TO: All Bourgault Dealers  
 ATTN: Service Manager, Parts Manager, Sales Manager  
 SUBJECT: Deteriorated Rubber Spacers on Saddle Tank Mounts

**FIX ON FAILURE** (Failure Code 15.18) Effective serial number range: Model yr. 2018 tanks with a saddle tank

### Proper Orientation of the new EPDM spacers

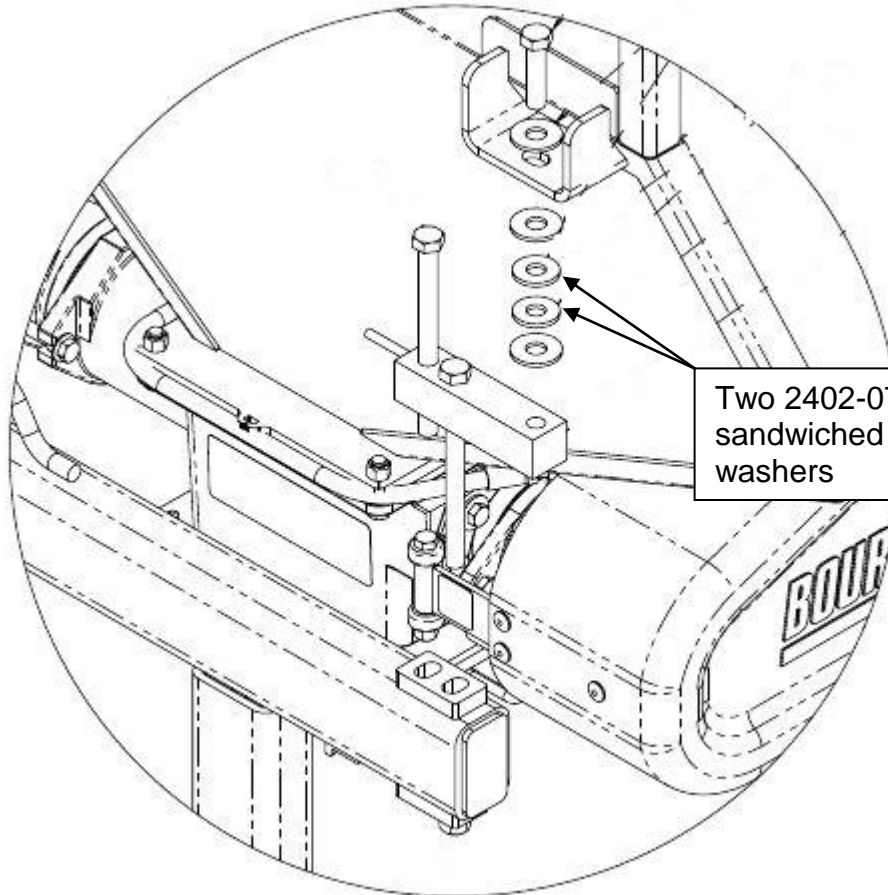
For model year 2018 the saddle tanks can be equipped with load cells. The saddle tank is mounted to the load cell and rubber spacers are used to provide some flexibility to this connection. In cases where a load cell is not used a steel block is used in its place. It has been identified that the neoprene material originally used in these rubber spacers may deteriorate when exposed to the outdoor environment. A new EPDM rubber material has been sourced and is now being used for these rubber spacers. In locations where the neoprene washers have deteriorated they should be replaced with the new EPDM rubber spacers.

Two 2402-07 rubber spacers sandwiched between two flat washers
